London Luton Airport Expansion

**8.118 Applicant's Response to Issue Specific Hearing 4 Action 7 –
Update on Road Safety Audits**

Report title:	Stage 1 Road Safety Audit Designer's Response-M1 Junction 10
Date:	November 2023
Document Reference and Revision:	TR020001/APP/8.118
Prepared by:	Neil Scott
On behalf of:	Luton Rising

Figure 2.1: Locations of Problems Identified within the Audit

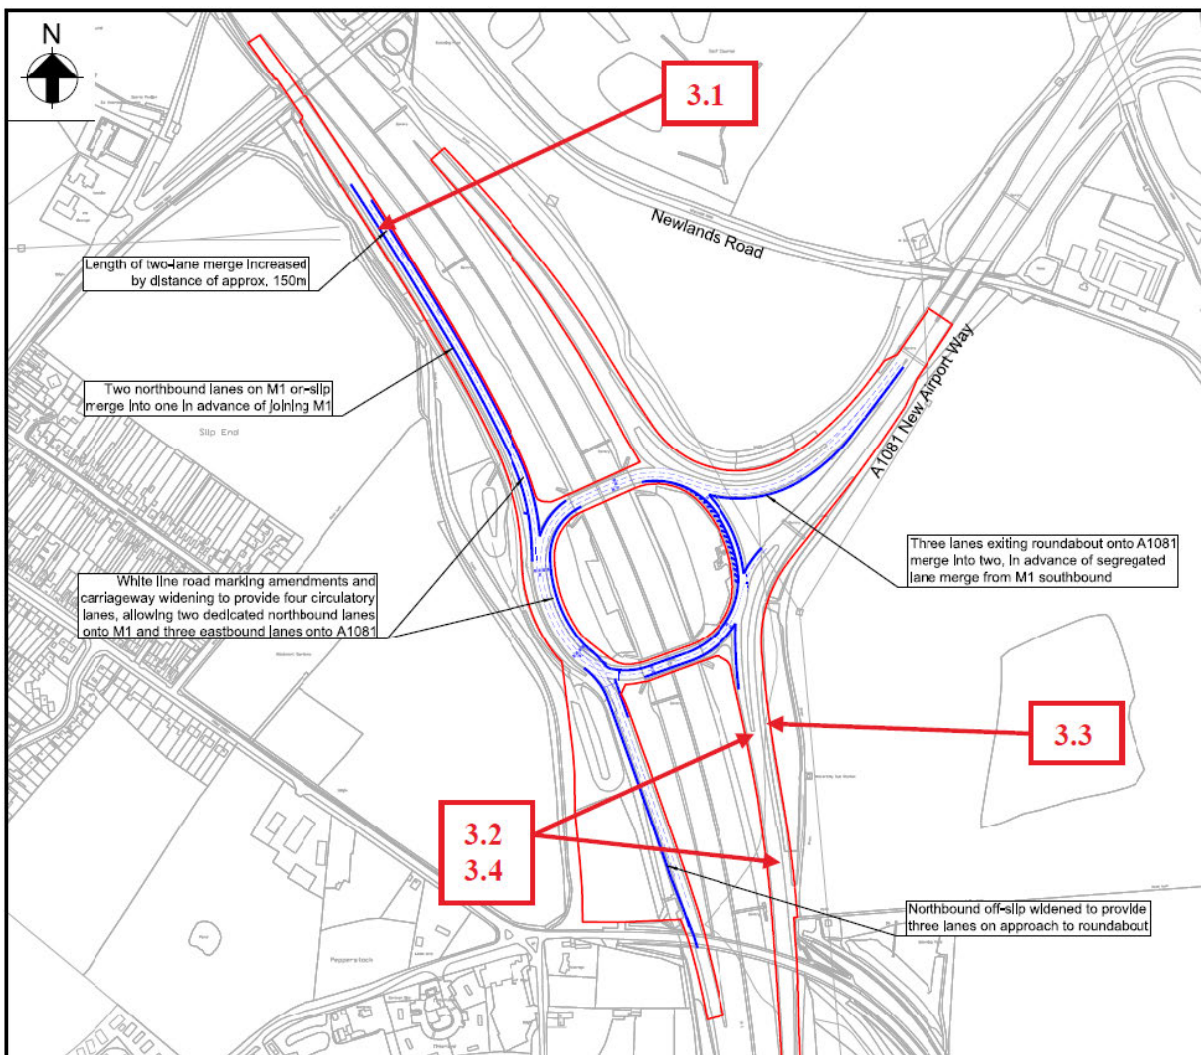
Ref.	RSA Problem	RSA Recommendation	Design Organisation Response	Overseeing Organisation Response	Agreed RSA Action
3.1	Drawing LLADCO-3C-ARP-SFA-HWM-DR-CE-0009 indicates that the length of the two-lane merge is to be extended by 150m. This may result in forward visibility of the merge point being compromised by an existing hidden dip in the northbound on-slip. This problem increases the risk of side swipe and loss of control type collisions.	Ensure that sufficient forward visibility of the merge is maintained.	Accepted. Forward visibility would be checked at the detailed design stage to ensure that appropriate visibility of the merge is maintained.	National Highways agree with the RSA. Traffic on the slip will be visible but the designer has agreed to checks.	Forward visibility would be checked at the detailed design stage to ensure that appropriate visibility of the merge is maintained.

3.3	<p>In Phase 2a and Phase 2b a two lane segregated left turn from the A1081 onto the M1 southbound slip road has been proposed. The existing southbound lane from the M1 J10 roundabout is proposed to join the segregated lanes with a short length of off-side merge. No details regarding infrastructure or stopping sight distances have been provided. Items such as VRS and signs between the segregated left turn lanes and off-side merge may obscure visibility for road users. This issue may increase the risk of side swipe, shunt, and loss of control type collisions. This</p>	<p>Provide sufficient intervisibility between the merge and segregated left turn lanes.</p>	<p>Accepted. See above response to Item 3.2 regarding the design or removal of the merge. If the exit off the circulatory is retained, there is scope to amend the alignment of the segregated left turn and separating island in order to accommodate potential VRS, signage and visibility requirements. This would be addressed at the detailed design stage.</p>	<p>National Highways agree with the RSA.</p> <p>It would be interested to explore the potential for closing the eastern circulatory or S/B merge exit as mentioned. That could remove a couple of issues, but signing for route finding would be key.</p>	<p>Amend the alignment of the segregated left turn and separating island in order to accommodate potential VRS, signage and visibility requirements. This would be addressed at the detailed design stage.</p> <p>The opportunity to close the eastern circulatory or southbound merge will be considered at the detailed design stage.</p>

Figure 2.1: Locations of Problems Identified within the Audit

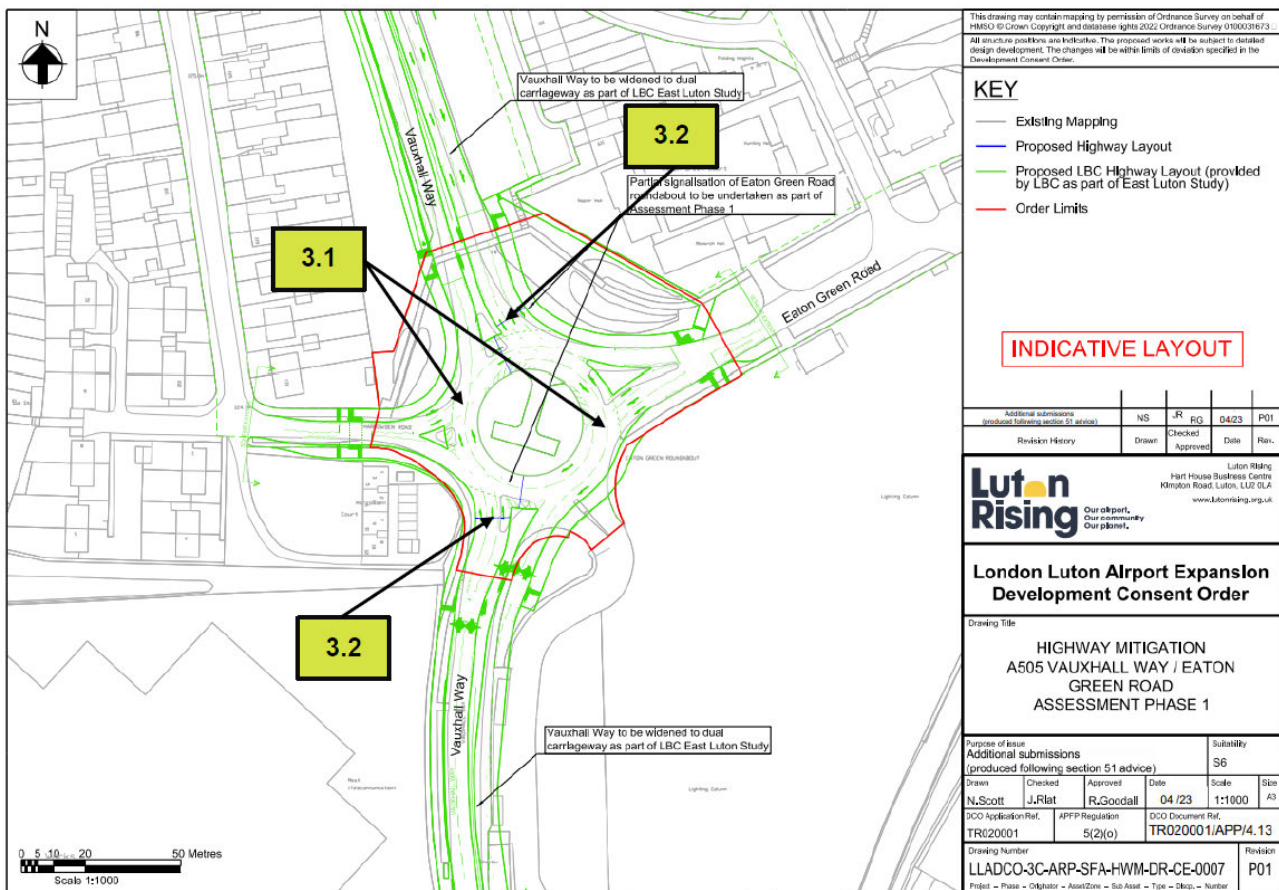
Ref.	RSA Problem	RSA Recommendation	Design Organisation Response	Overseeing Organisation Response	Agreed RSA Action
3.1	The stacking distance between successive signal stop lines is quite short, which could lead to vehicle queues extending across the Harrowden Road and Eaton Green Road entries to the roundabout. As a result, collisions could occur as road users attempt to weave through queues or change lane suddenly.	It should be ensured that the road layout and traffic signalling strategy is suitable to prevent vehicles queuing across entry arms to the roundabout.	Accepted. The operation of the signals would be optimised to ensure the efficient operation of the junction and would include consideration of queue lengths within the circulatory carriageway of the roundabout.	Design Response is accepted.	RSA recommendation to be adopted as part of the detailed design.

3.2	The widening to three lanes on the approaches to the junction could increase the likelihood of the primary signals being masked by high sided vehicles. If a red signal is not clearly visibly to road users, there could be an increased risk of overshoot collisions or accidents involving sudden and late braking, such as rear-end shunts.	High-mounted duplicate primary signals should be provided on the Vauxhall Way approaches to the junction.	Accepted. The provision of high-mounted signals would be considered at the detailed design stage.	Design Response is accepted.	RSA recommendation to be adopted as part of the detailed design.

Figure 2.1: Locations of Problems Identified within the Audit

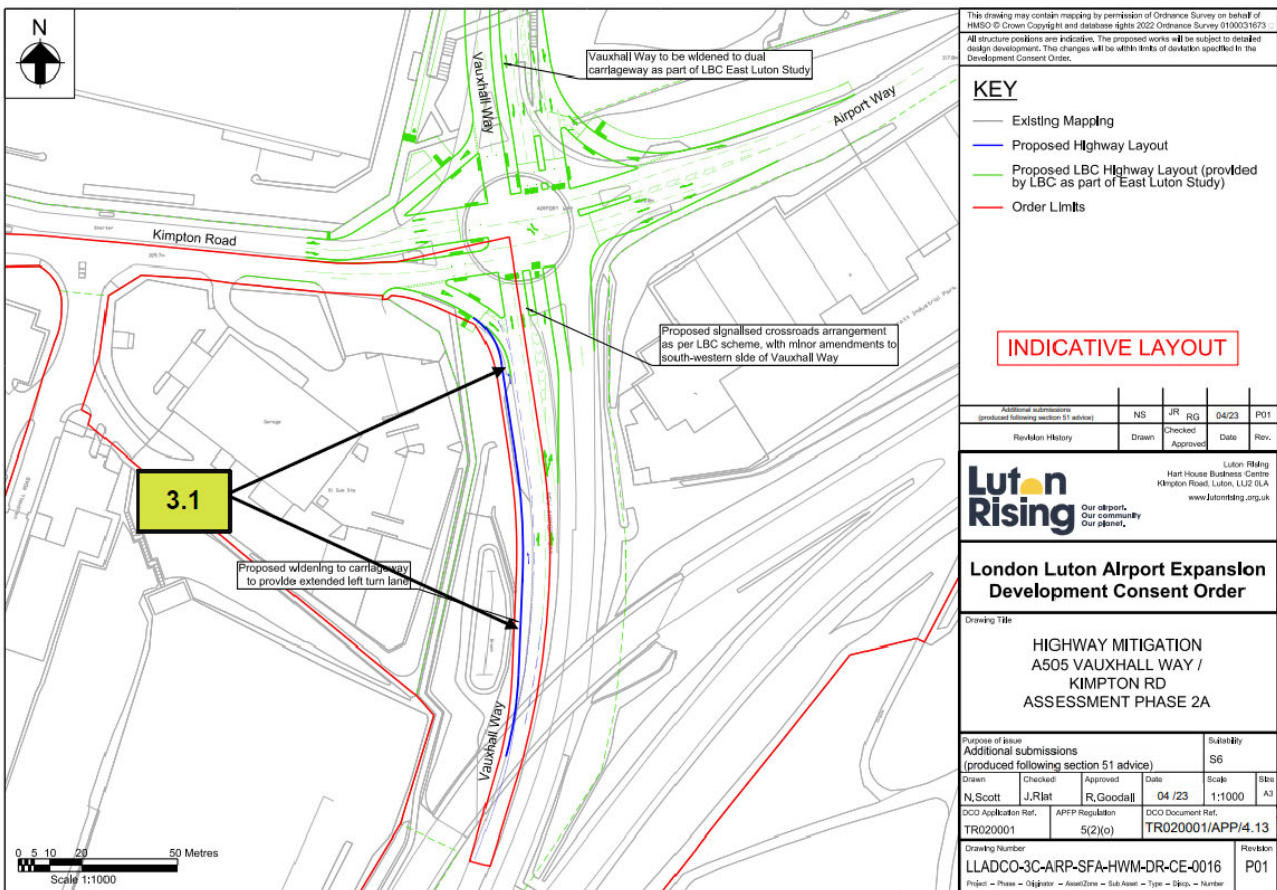
Ref.	RSA Problem	RSA Recommendation	Design Organisation Response	Overseeing Organisation Response	Agreed RSA Action
3.1	There are lamp columns and trees within the verge that will be closer to the edge of carriageway when the road is widened. A temporary vertical concrete barrier is also present, but it is not clear whether this will be retained. If not, the lamp columns and trees could present a roadside hazard to road users if they lose control and collide into the objects. Injuries could be serious if vehicles are brought to an abrupt halt or redirected violently.	A suitable vehicle restraint system should be provided, unless the lamp columns are replaced by passively safe systems and any mature trees removed that will be close to the edge of carriageway.	Accepted. This would be addressed at the detailed design stage.	Design Response is accepted.	RSA recommendation to be adopted as part of the detailed design.

Figure 2.1: Locations of Problems Identified within the Audit

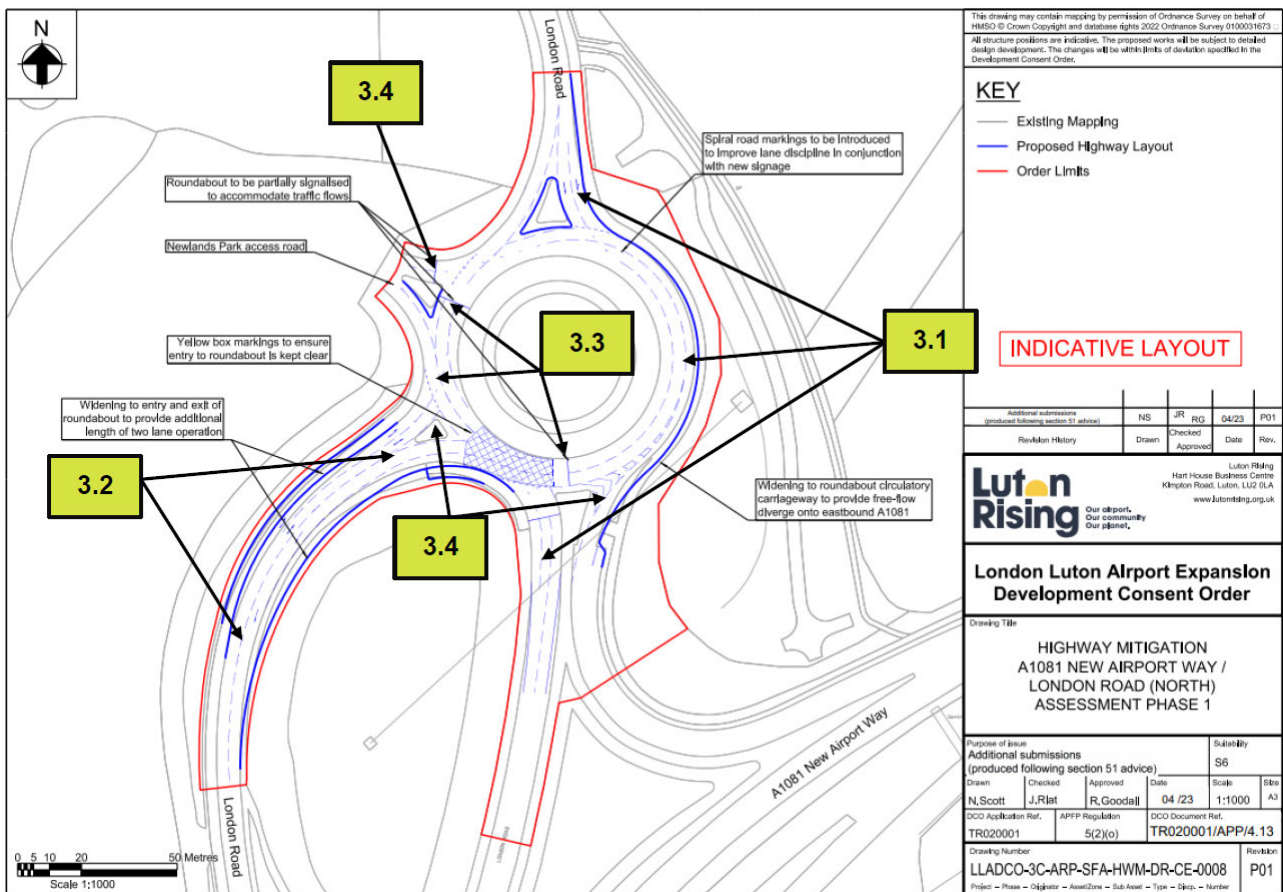
Ref.	RSA Problem	RSA Recommendation	Design Organisation Response	Overseeing Organisation Response	Agreed RSA Action
3.1	Road users may not be able to anticipate which lanes to use to reach their intended destination. For example, on the A1081 approach, road users may use the middle lane to reach London Road (north) rather than the designated offside lane. On the London Road southbound approach, road users may use the offside lane to reach the A1081 (which they can currently), instead of using the nearside lane only. If road users find that they are in the incorrect lanes, side swipe and lane change collisions could occur.	Lane destination signs and road markings should be provided at strategic locations to inform road users of the correct lanes to use.	Accepted. Lane markings and signage would be provided to clarify which destinations are reached from each approach lane. This would be addressed at the detailed design stage.	Design Response is accepted.	RSA recommendation to be adopted as part of the detailed design.

Ref.	RSA Problem	RSA Recommendation	Design Organisation Response	Overseeing Organisation Response	Agreed RSA Action
3.3	The stacking distance between successive signal stop lines is quite short, which could lead to vehicle queues extending across the London Road southern entry to the roundabout. As a result, collisions could occur as road users attempt to weave through queues or change lane suddenly.	It should be ensured that the road layout and traffic signalling strategy is suitable to prevent vehicles queuing across entry arms to the roundabout.	Accepted. The operation of the signals would be optimised to ensure the efficient operation of the junction and would include consideration of queue lengths within the circulatory carriageway of the roundabout.	Design Response is accepted.	RSA recommendation to be adopted as part of the detailed design.

3.4	The widening of the roundabout could make crossing movements more hazardous for pedestrians and cyclists, especially at times of high vehicle flows (peak times) or when speeds could be higher at off-peak times. This could be a particular issue on the London Road southern arm and on the A1081 exit arm. On the Newlands Park access entry to the roundabout, the position of the signal stop line could make it difficult to provide a crossing point. Vulnerable road users could be at increased risk of being struck by vehicles under such circumstances.	It should be ensured that the pedestrian and cycle crossing points will be safe to use (for example, controlled crossings may be beneficial at some locations).	Noted. The proposed realignment on the A1081 exit arm increases the crossing distance by approximately 1.0m and could be reduced at the detailed design stage to minimise any additional crossing distance. The pedestrian demand on the London Road (south) exit arm is likely to be very low, and the proposed signalisation of the A1081 arm should create gaps in the traffic for pedestrians to cross. In addition, the widening to the London Road exit is c1.5m and would only add c.1 second to the crossing time for pedestrians.	Design Response is noted. Recommend that non-motorised user demand is reviewed as part of the detailed design.	RSA recommendation is noted and overseeing organisation comment accepted.

Ref.	RSA Problem	RSA Recommendation	Design Organisation Response	Overseeing Organisation Response	Agreed RSA Action
			The position of the stop line at the exit from Newlands Park would be adjusted to accommodate a pedestrian crossing at the detailed design stage.

Figure 2.1: Locations of Problems Identified within the Audit

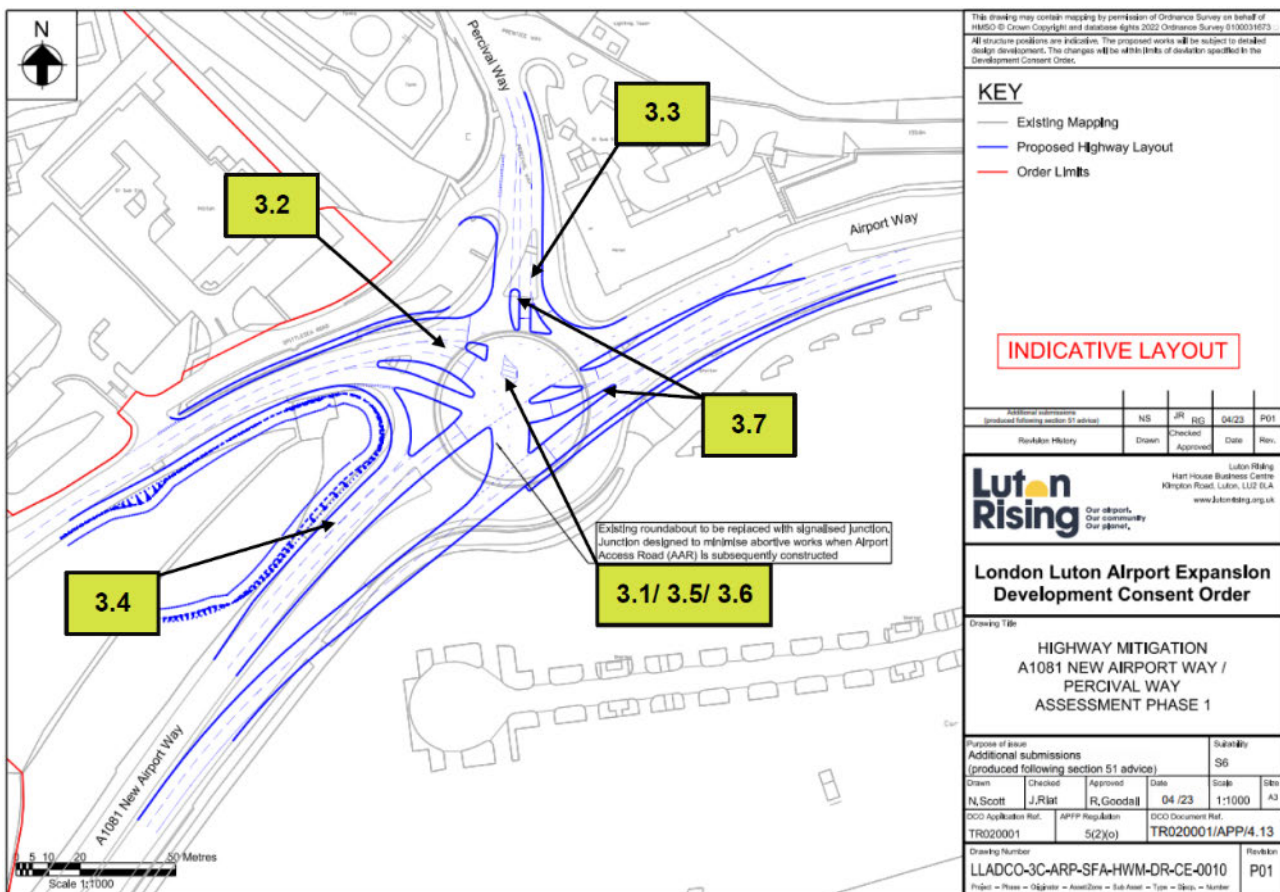
Ref.	RSA Problem	RSA Recommendation	Design Organisation Response	Overseeing Organisation Response	Agreed RSA Action
3.1	It was noted that the existing roundabout for New Airport Way and Percival Way is on a steep gradient which slopes away from the north side. With the introduction of the signalised junction there could be a level difference between each approach, which could create an adverse camber for vehicles turning at the junction. This could increase the risk of loss of control collisions and could cause larger, high sided vehicles to turn over.	The levels should be checked for each approach ensuring a level junction platform with no adverse cambers for vehicle turning movements.	Accepted. It is accepted likely that some regrading would be required on the approaches to and within the junction. This would be addressed at the detailed design stage.	Design Response is accepted.	RSA recommendation to be adopted as part of the detailed design.

Ref.	RSA Problem	RSA Recommendation	Design Organisation Response	Overseeing Organisation Response	Agreed RSA Action
3.3	The vertical alignment for Percival Way on the approach to the junction is on a steep downhill section. With the introduction of the signal control there could be more sudden braking movements such as when the lights change from green to red. This combined with being on a downhill section could increase the risk of loss of control and subsequent shunt and junction overshoot collisions.	A level dwell area of suitable length should be created for this arm of the junction.	Accepted. See response to 3.1.	Design Response is accepted.	RSA recommendation to be adopted as part of the detailed design.

3.5	With numerous lanes and splitter islands, road users turning at the signalised junction might have difficulty manoeuvring into the correct lane for their required destination. These potentially late lane swapping manoeuvres could increase the risk of side swipe collisions with other users. Furthermore, they might get confused and turn into the incorrect	At detailed design stage appropriate signing, lining and bollards should be installed at the junction to guide users to the correct lanes for their desired destination. Signal phasing should be reviewed ensuring minimal conflicts between opposing traffic	Accepted. Appropriate signage, road markings and bollards would be provided at the detailed design stage to reinforce appropriate manoeuvres throughout the junction.	Design Response is accepted.	RSA recommendation to be adopted as part of the detailed design.

Figure 3.1: Swept Paths - Frank Lester Way / Eaton Green Road

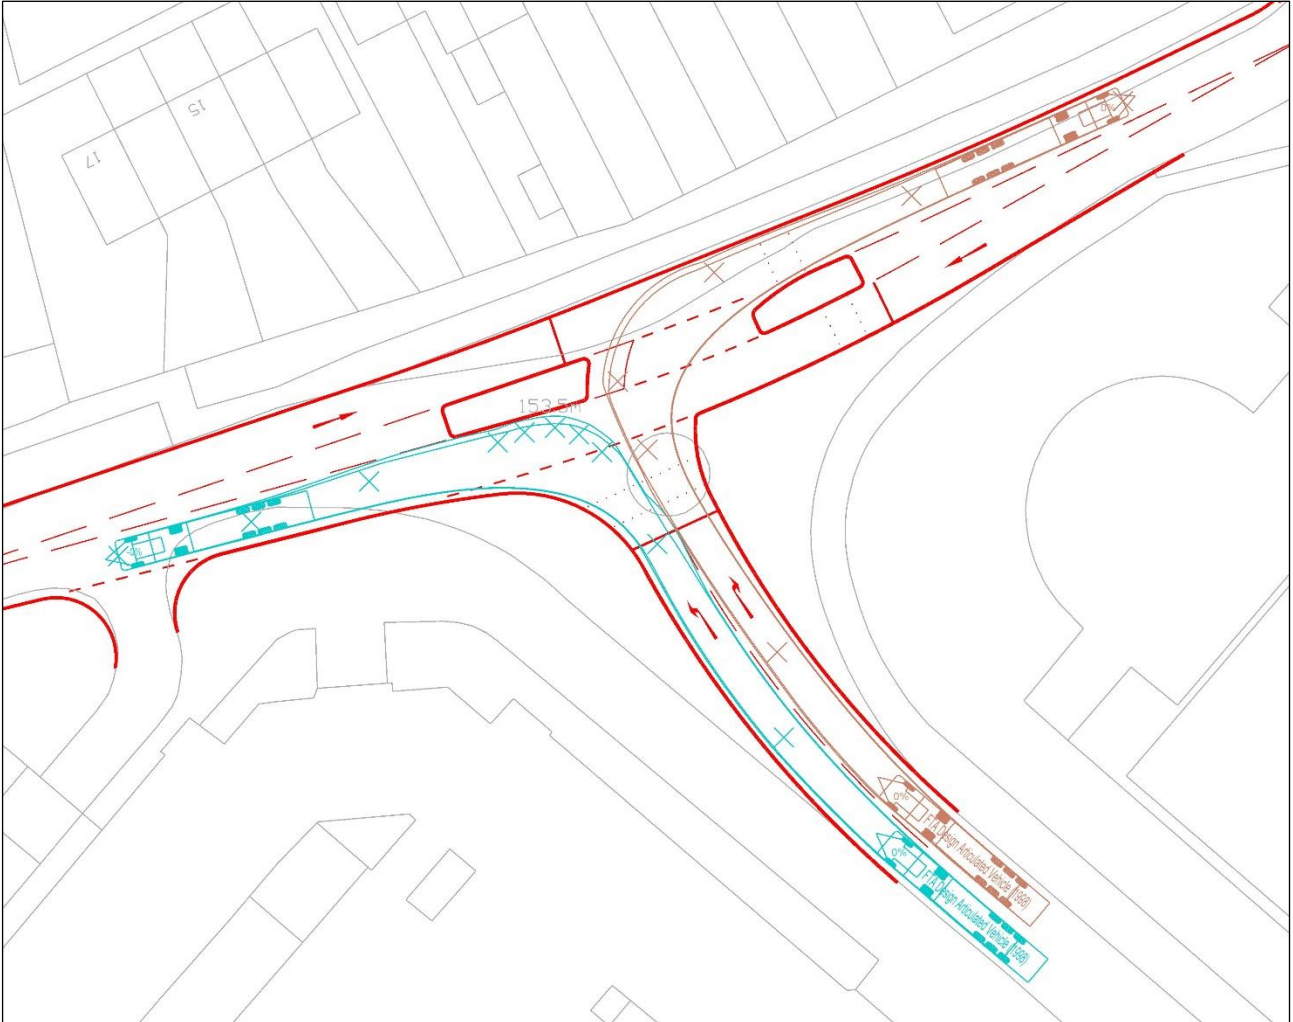
Ref.	RSA Problem	RSA Recommendation	Design Organisation Response	Overseeing Organisation Response	Agreed RSA Action
	result, they may mount the kerbs or strike street furniture, creating a hazard to other road users or pedestrians walking along the footway.	geometry of the junction amended if required.	into Eaton Green Road was achievable for vehicles including articulated HGVs and buses – see Figure 3.1	checked at subsequent design stages.	at subsequent design stages.

3.2.1 Figure 3.1 above shows the swept path analysis for 16.5m articulated HGV manoeuvres at the proposed signalised junction between Frank Lester Way and Eaton Green Road.
